STANDARD FIELD SERVICE BULLETIN

FSB Number	CHRAEFSB2015-24
Author	Rajesh Verma
Date	05/18/2015
Subject	SIM No Detect, SD Card No Detect / No Operation, Front Camera Flash No Function, Vibrator No Function
Model Affected	XT1063, XT1064, XT1068, XT1069, XT1072, XT1077, XT1078, XT1079
Level Of Repairs	Level 2

Photo 1

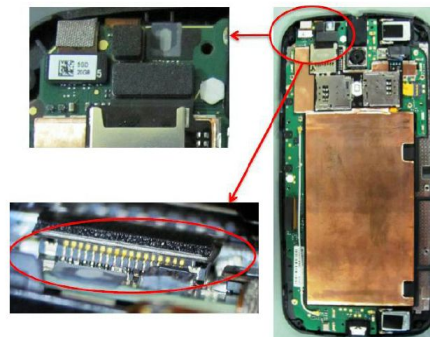
Engineering analysis identified this issue was related to a Daughter board assembly FPC (flex panel connector) disconnecting after drop test. This issue was identified on part number MEDBU14001C.

- Use only supplier A part number MEDBU14005B (Flex cable color is copper).
- If supplier A parts are not in stock then use supplier B part number MEDBU14001C till supplier A part number MEDBU14005B are available (supplier A parts availability end of June, 2015)

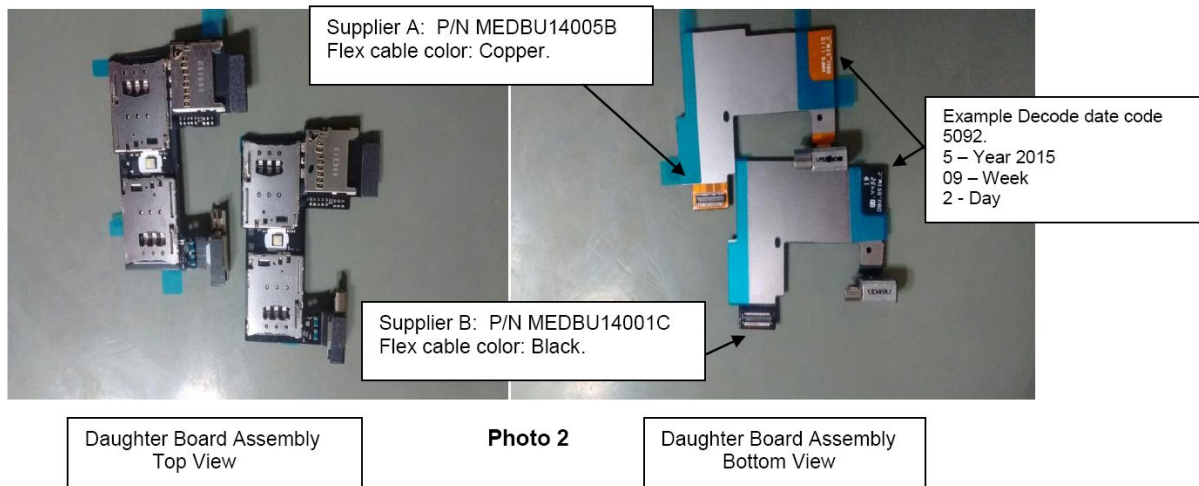
Note: See below photo 2 to identify supplier A and Supplier B parts and date code from supplier B parts.
